A Review of the 2016 Diavik Diamond Mine Wildlife Monitoring Report and 2017 Wildlife Comprehensive Analysis Report

Environmental Monitoring Advisory Board

July 2017

Figure I: A) Grizzly bear observations related to observation year. B) Days with bear visitations to East Island related to observation year. C) Days deterrent actions were utilized related to observation year (data from Tables 5 & 6 of the WMR 2016).

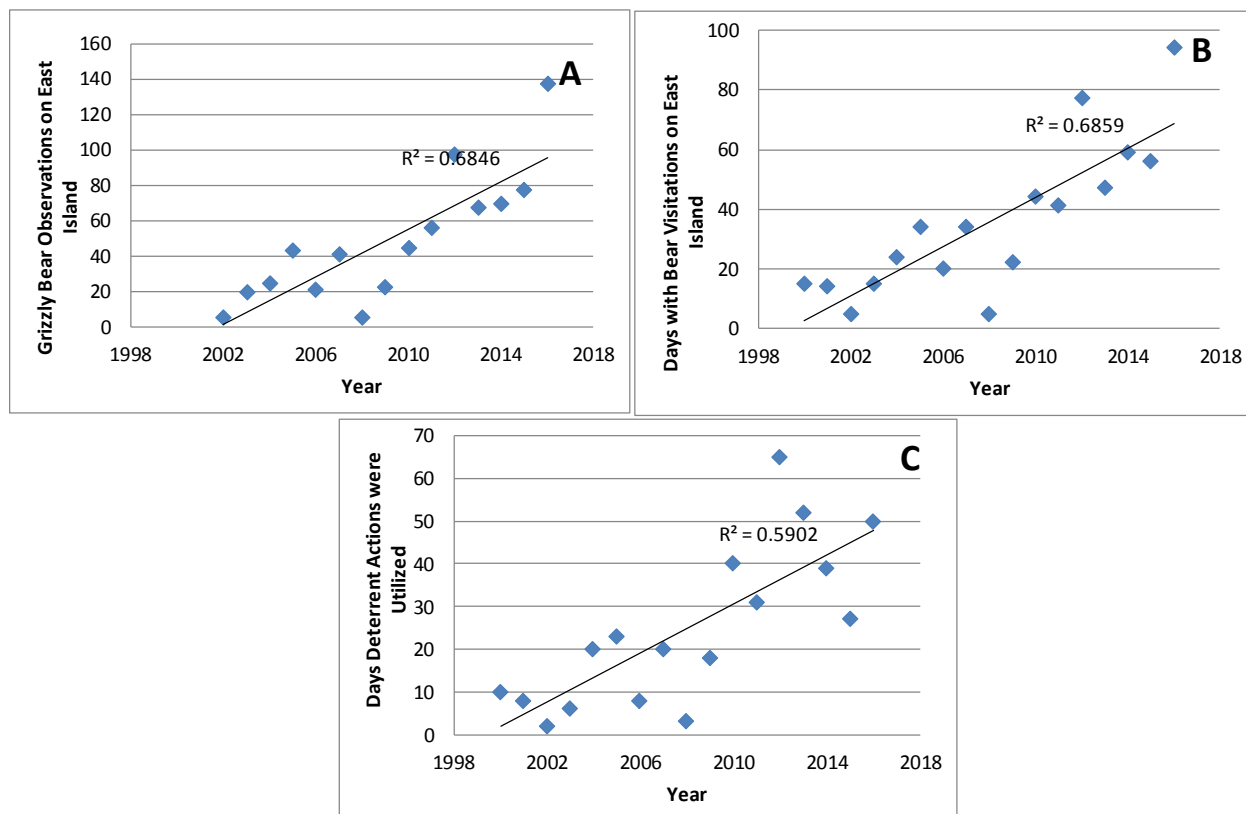
There appears to be an increasing trend in the number of incidental grizzly bear observations over time (Figure 1A), the number of days with bear visitations to East Island over time (Figure 1B), and the number of days that deterrent actions were utilized over time (Figure 1C). DDMI has indicated that the number of incidental observations of grizzly bears does not appear to be influenced by the number of people on site (WMR, Section 4.2.2.2). We reiterate our previous recommendations that, **given the increase in grizzly bear incidental observations near the Mine over time, DDMI should increase vigilance and future years of data collection should be used to evaluate whether the current deterrent system is effective at reducing grizzly bear presence near the Mine. DDMI should discuss their adaptive management process and their response action in the case that the current deterrent system is found to be ineffective.** Current data on the abundance and distribution of grizzly bear (hair snagging program) would help inform this potential issue of increasing grizzly bear observations over time.
